# Access Compliance Report

## Public Rights-of-Way

### (Curb Ramps)

Intersection ID: 11844	Main Street: E_W_T_HARRIS_BV	Cross Street: TANTILLA_CR	Location: SW
ADA ID: 02CB795619FD	Ramp Type: PerpDiag	Initial Pass/Fail: Fail	Overall Compliance: No
Severity Score: 25			
Codes/Mitigation Info/Possible Solution		Field Measurements/Component Compliance

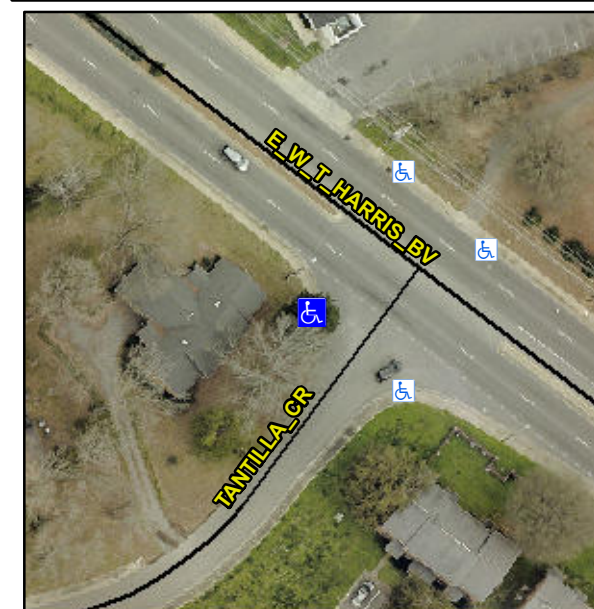
**R304.2.2**

Compliance	Description	Data	Compliance	Description	Data
N/A	Ramp Length (in)	59.5	No	Ramp Slope (%)	12.4
Yes	Ramp Width (in)	48.0	Yes	Ramp XSlope (%)	1.6
N/A	Flare Type LT	N/A	N/A	Flare Type RT	N/A
N/A	Flare Slope LT (%)	N/A	N/A	Flare Slope RT (%)	N/A
N/A	Flare Traversable LT?	N/A	N/A	Flare Traversable RT?	N/A
N/A	Landing Length (in)	N/A	N/A	DWS Provided?	N/A
N/A	Landing Width (in)	N/A	N/A	DWS Contrast?	N/A
N/A	Landing Slope (%)	N/A	N/A	DWS Length (in)	N/A
N/A	Landing X Slope (%)	N/A	N/A	DWS Full Width?	N/A
N/A	Landing Curb? (Y/N)	N/A	N/A	DWS Offset (in)	N/A
N/A	Shared Landing?	N/A			
N/A	Gutter Ponding?	N/A	N/A	Gutter Slope (%)	N/A
N/A	Gutter Lip Ht (in)	N/A	N/A	Gutter X Slope (%)	N/A
N/A	Painted X Walk1?	No	N/A	Painted X Walk2?	No
	X Walk 1 Direction	To SE		X Walk 2 Direction	To NE
N/A	X Walk 1 Width (in)	N/A	N/A	X Walk 2 Width (in)	N/A
	X Walk 1 Slope (%)	0.2		X Walk 2 Slope (%)	4.0
	X Walk 1 X Slope (%)	2.3		X Walk 2 X Slope (%)	0.7

**Remove & Replace Curb Ramp With Two New Directional Ramps or Equivalent.**
